Addendum No. 1

Re: Part B - James M. Seals, JR. Park – Athletic Restroom/ Concession and Field Improvements
504 Texas Street, Mobile, AL 36603
Project No. PR-041-20
Part C - Hackmeyer Park – Improvements Phase 2
3810 Conway Drive South, Mobile, AL 36608
Project No. PR-034-21

Date: November 14, 2022

SCALE: 1 1/2"=1'-0"

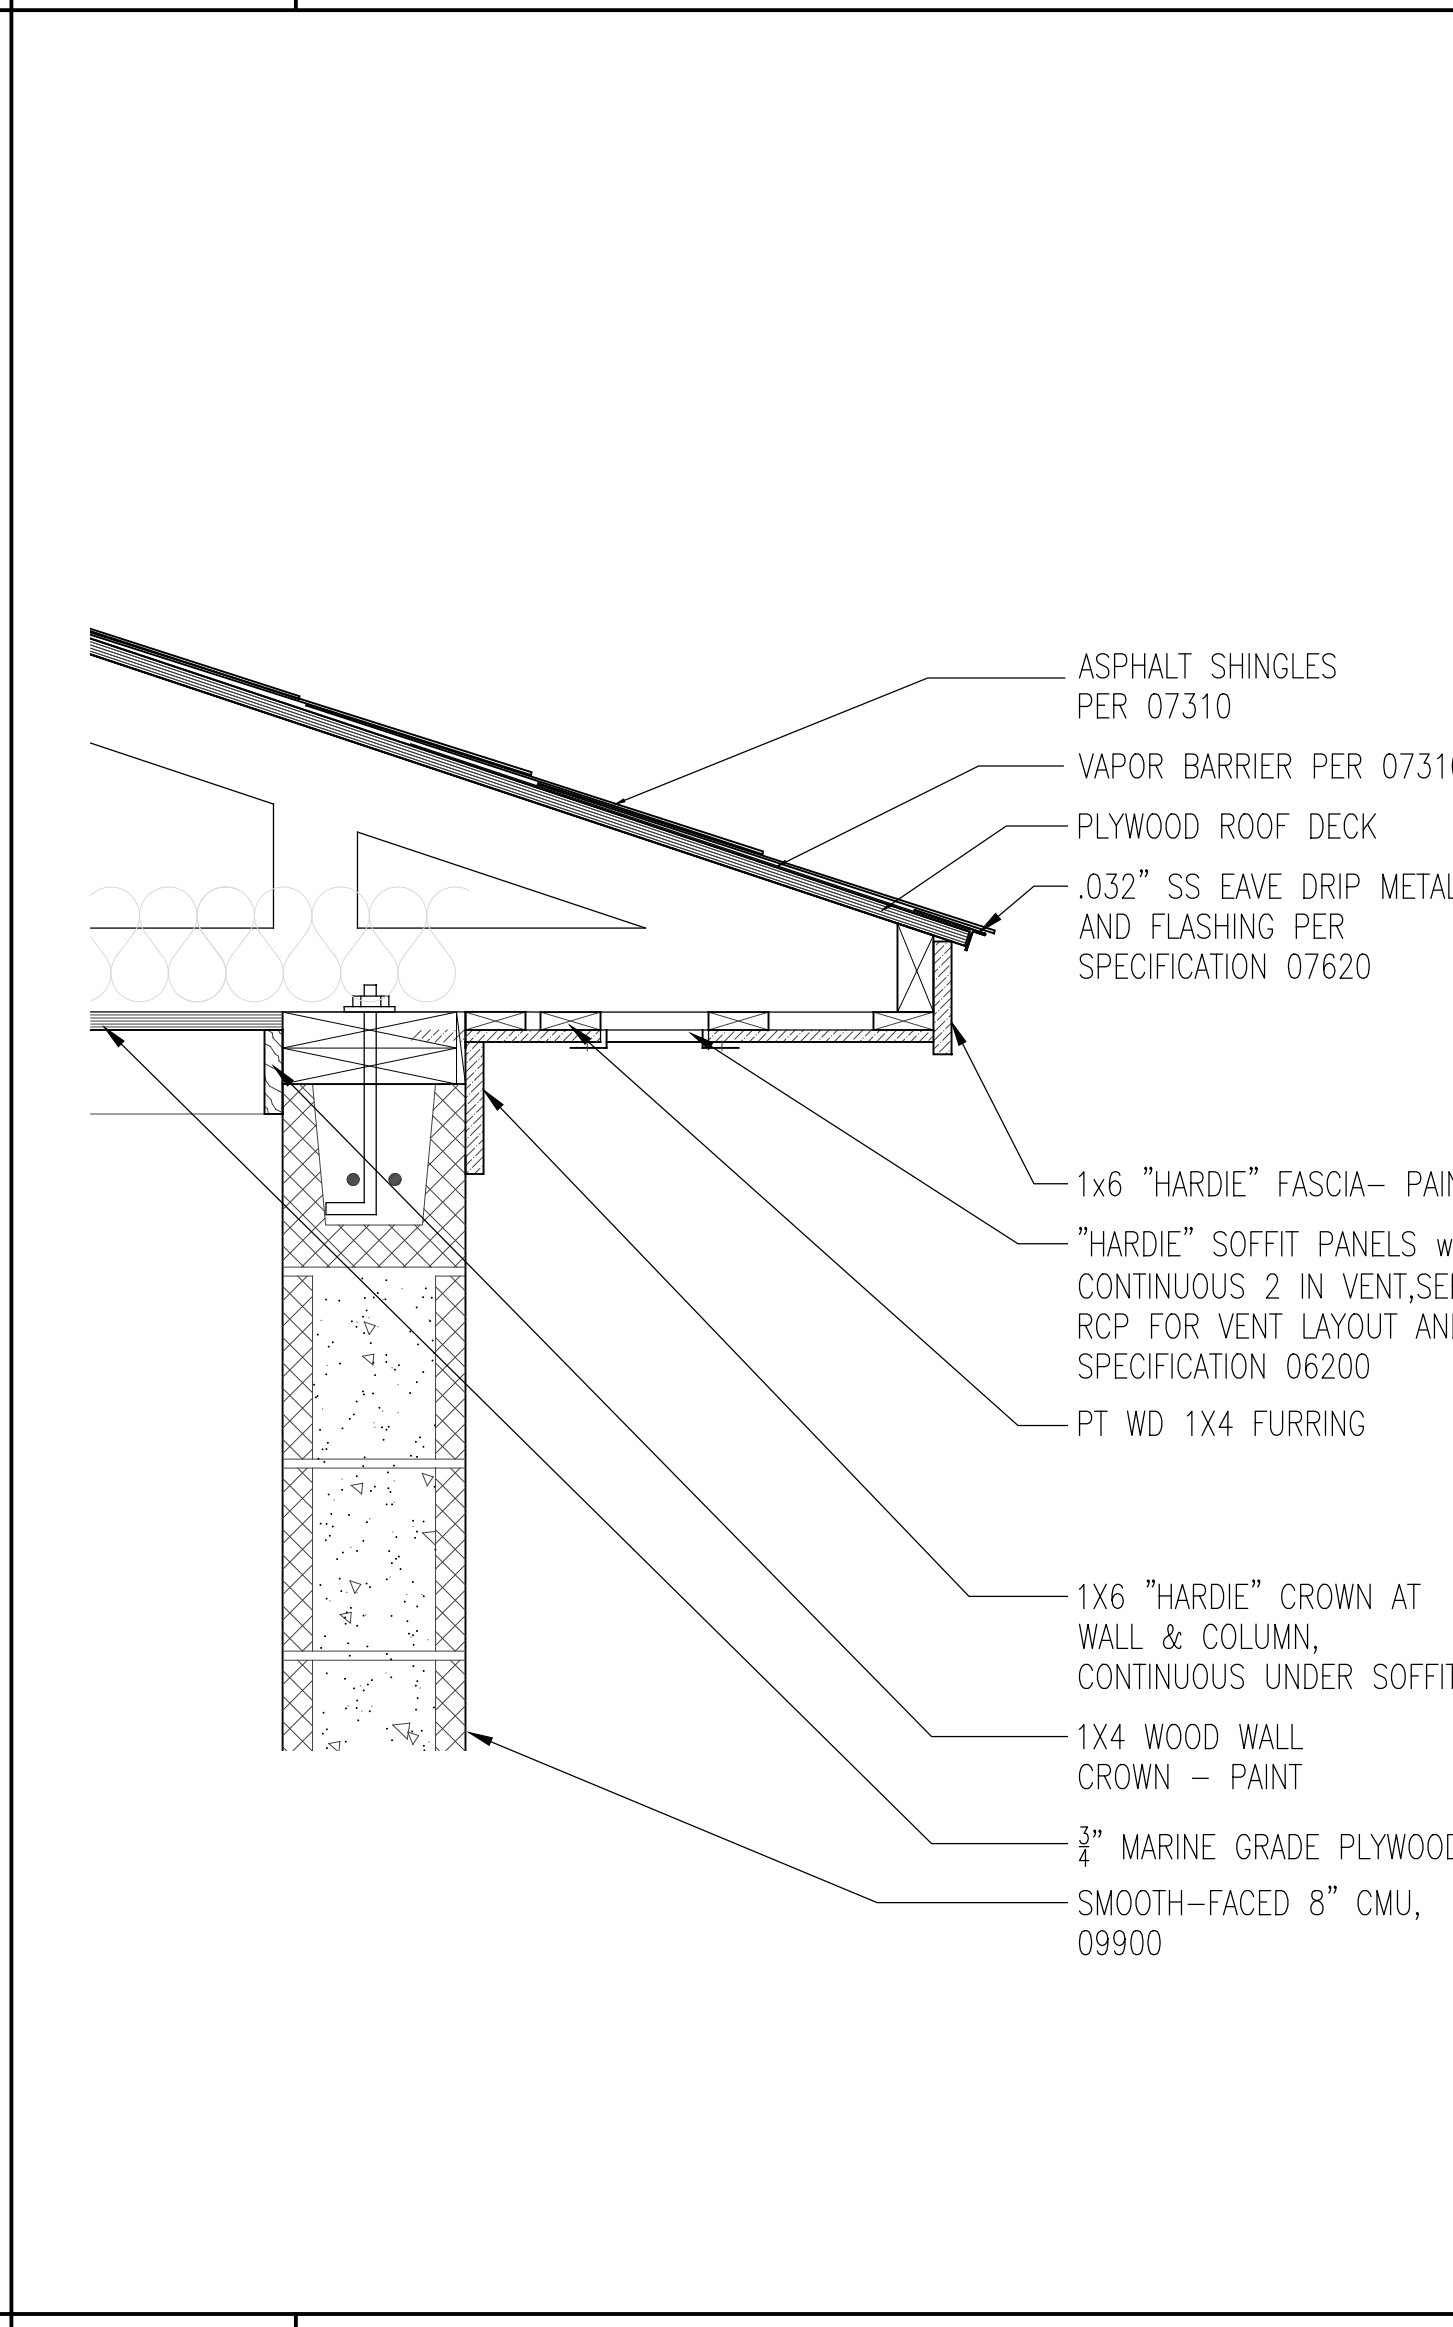
Item 15: Sheet A1.3 Building – Roof Plan

Replace this sheet dated 11.02.22 with the attached revised sheet of same title A1.3, dated November 07, 2022 and labeled Revision 01 (Addendum No. 1). Substantial changes include the following:

- Update detail section marks on roof plan.
